**Reversing Camera Misted Up and/or Droplets Forming in the Camera Lens: Rework Rear Lid Release (182/21)**

Model Line: **Panamera (971)**

Model Year: **As of 2017 up to 2021**

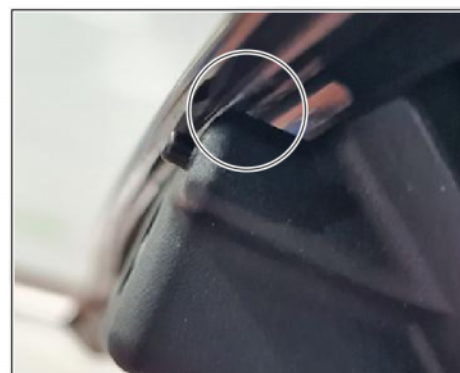
This may be caused by joint tolerances of the components in the reversing camera area as well as tolerances in the thickness of the body seam seal. They can cause the release for the rear lid in which the reversing camera is installed to touch the rear lid. If this happens, there is a gap between the release and the rear lid that can allow water to penetrate into the reversing camera.

*Formation of drops*

*Contact between PVC seam and rear lid release*

*Gap between release and rear lid*

Action required: In the event of a complaint, rework rear lid release and replace reversing camera.

*Marking area to be removed*

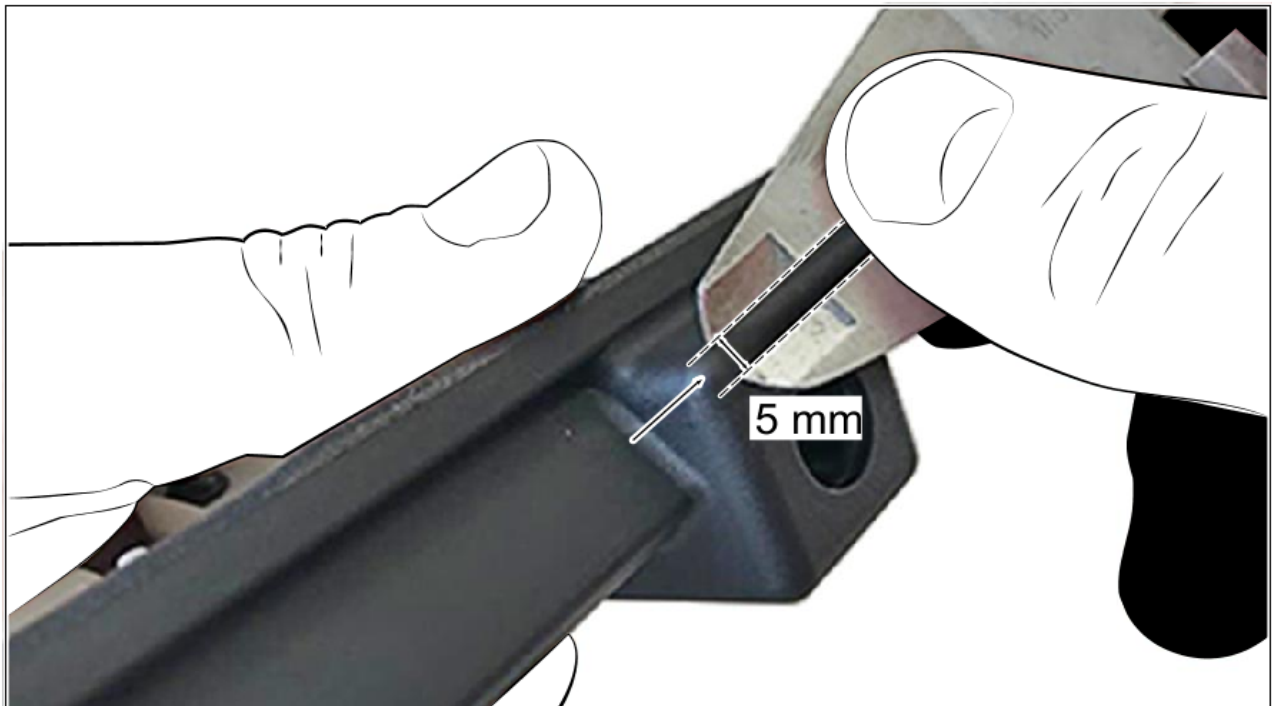
Procedure: Affix a max. 5 mm/ 0.20 in wide chamfer to the actuator for the rear lid to prevent contact between the rear lid release and rear lid and to ensure that the seal is secure.

- 1 Set calliper gauge to a width of 5 mm/ 0.20 in. Then scribe the surface to be removed as shown in  $\Rightarrow$  *Marking area to be removed* using the calliper gauge.

- 2 Mask the spray nozzle for the reversing camera at the actuator for the rear lid as shown in  
⇒ *Masking spray nozzle* using suitable adhesive or insulating tape.

*Installing chamfer*

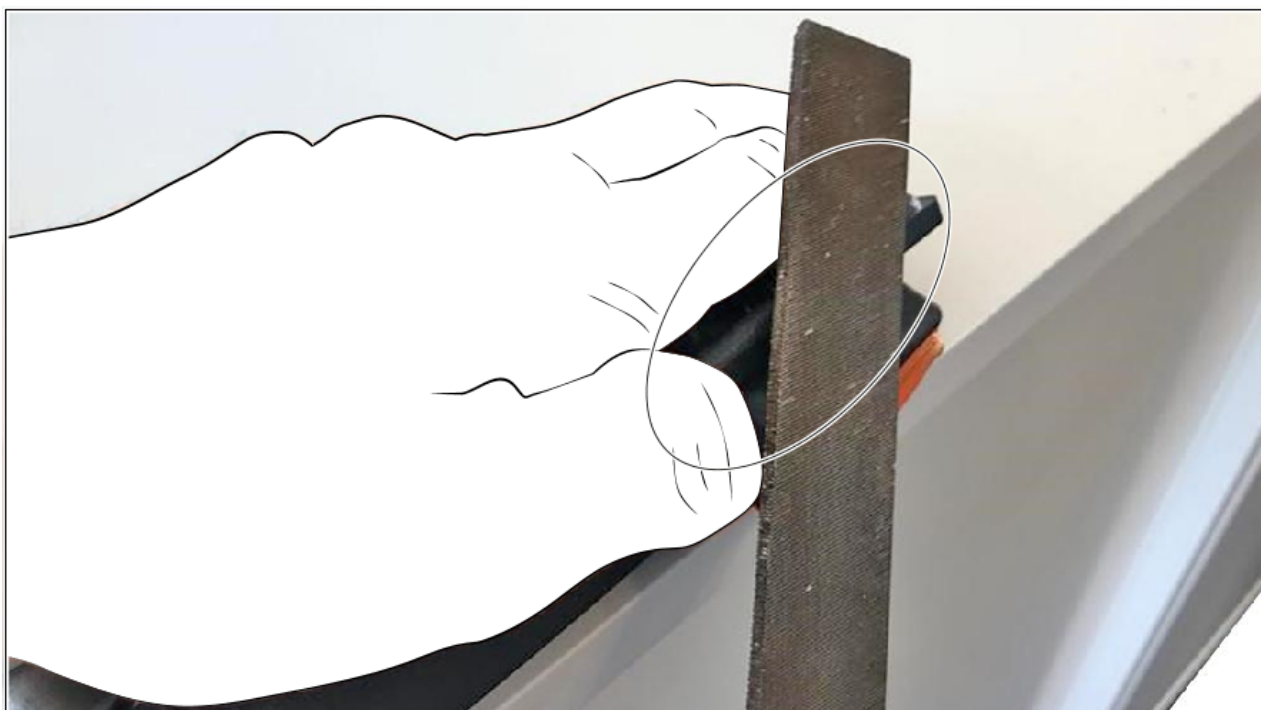
- 3 Remove the area you marked earlier using a fine-grained file over a width of max. 5 mm/ 0.20 in. ⇒ *Installing chamfer*

In most cases, it is sufficient to remove approx. 2-3 mm/ 0.08 — 0.12 in of material. Therefore, install the rear lid release in between and check the installation position after you have removed some material. Then, remove more material if necessary.
